Historic Architectural Review Commission
Staff Report for Item 16

Application Number: C2026-0024

Address: 1301 Whitehead Street

Description of Work:

Proposed Left Elevation showing flat roof modifications and gable cover over entry door.

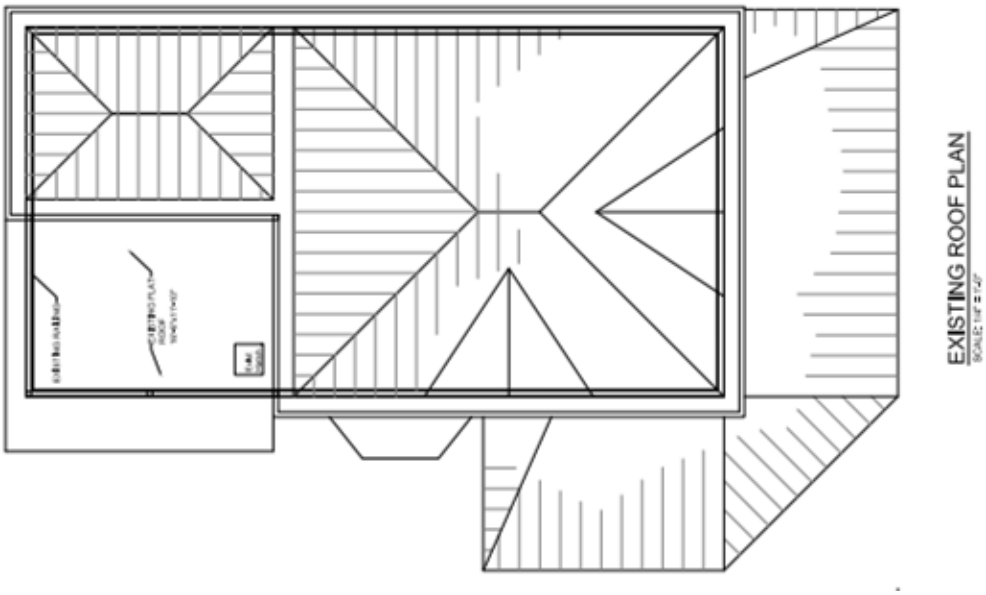
Overall, the proposed plans include some elements that do not comply with the HARC guidelines for contributing structures. The modification of the existing flat roof raise additional concerns, however the addition of railings on the flat roof may be considered with simpler more historically appropriate 2x2 balusters.

Proposed Roof Deck/Attic Plan.

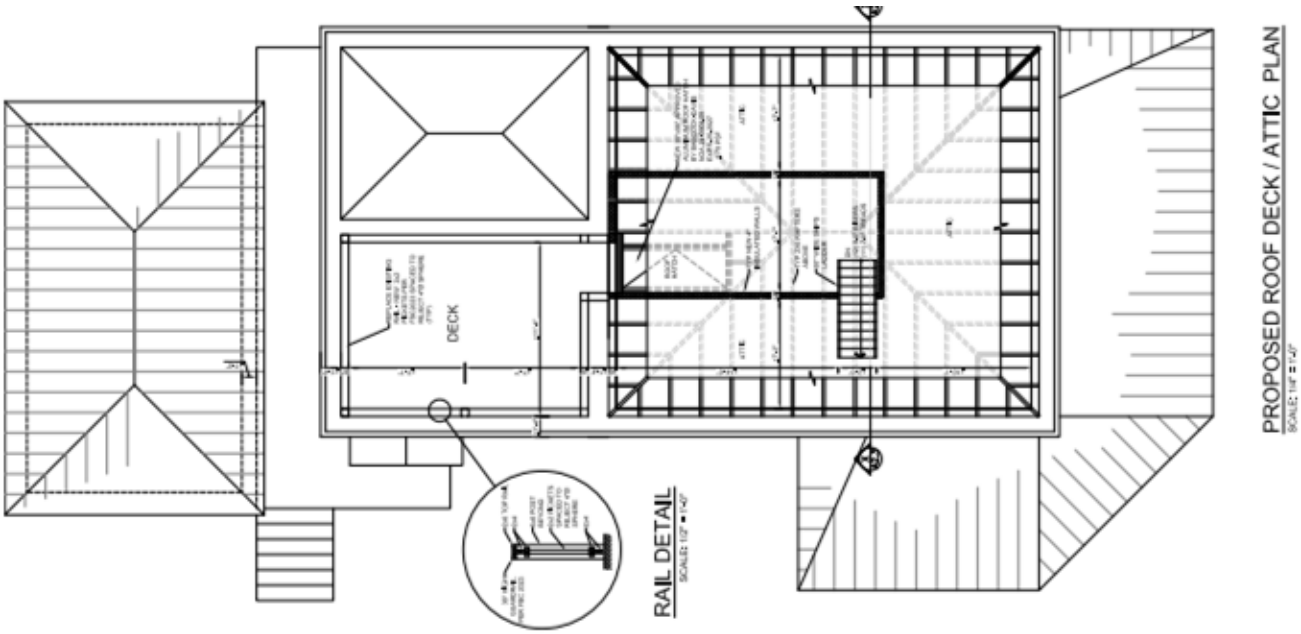
The proposed demolition and alteration of the historic hip roof to create new access by installing an aluminum roof hatch would remove original contributing fabric and alter the historic structure visible from the right of way. This approach is strongly discouraged by the **Guidelines for Additions, Guideline 2,** which requires that the removal of historic materials or alteration of character-defining features be avoided, and **Guideline 29**, which states that destruction of original elements must be minimized. Additionally, **Guideline 30** emphasizes that new work should be attached to non-historic or secondary areas whenever possible. The proposal is also inconsistent with **Guideline 17 of Additions**, which prohibits alteration of roof forms on contributing buildings when visible from the street.

Additionally, the proposal is inconsistent with the **Roofing Guidelines**, specifically Guidelines 4 and 5. **Guideline 4** states that the form and configuration of a roof must not be altered in pitch, design, materials, or shape unless returning the roof to a verifiable historic form. **Guideline 5** states that the public view of the roofline must not be altered by the addition of new features such as scuttles or roof hatches, and that such elements may only be allowed on roof surfaces not visible from the public right-of-way. The proposed aluminum roof hatch alters the existing roof configuration and introduces a new feature that is visible from the public right-of-way, which is not consistent with these guidelines.

Staff recommends that the aluminum roof hatch be relocated to a less visible location that does not front a public street and does not require alteration of the historic roof form. Existing landscaping does not provide adequate screening to reduce its visibility.
